Product hierarchy no. *			Part no.	SBU	Type / Description	Customer part no.
SBU PG	PGU	Type				
90	004	001	0000001000	See list below	Voltage Selector	SWP

Modification of approval marks, extension of operating-cycle and -temperature markings.

SWP					0118.2278	
creation date	created by	release date	released by	notification no.	revision	page
2015-04-07	schaidro	2015-05-12	schaidro			1 of 2

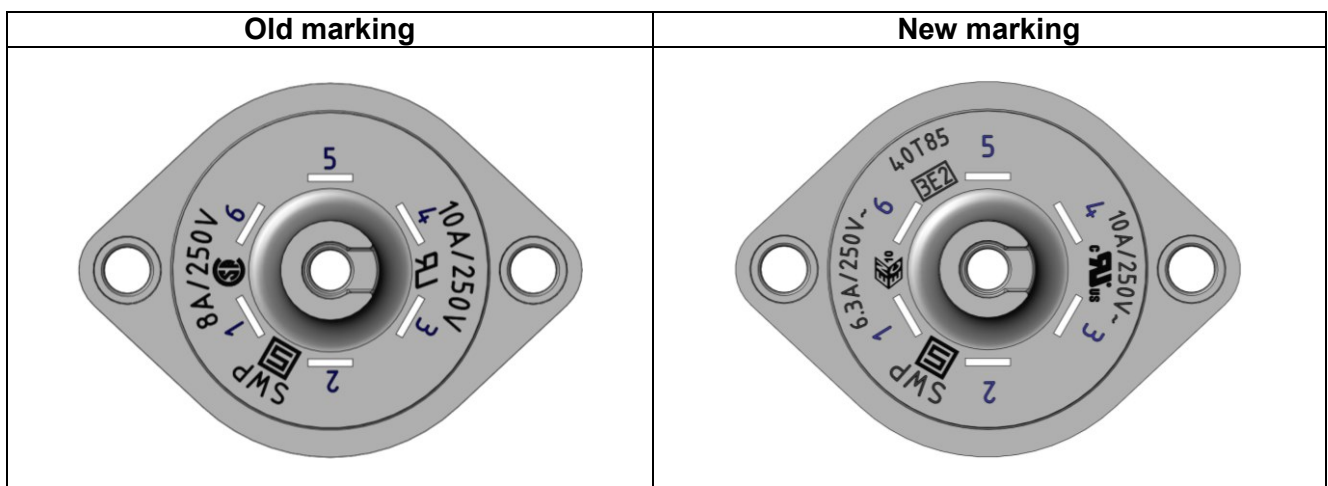
Old marking	New marking
-	ENEC 10 6.3A/250V~
-	3E2 ¹
-	40T85 ²
UR 10A/250V CSA 8A/250V	cURus (combined) 10A/250V~
¹ 3E2 ~ Lifetime of 300 operating cycles	
² 40T85 ~ Allowable Operation Temp. -40°C to 85°C

New Approval mark by ENEC10
Consolidation of North American approval marks with the combined cURus mark.
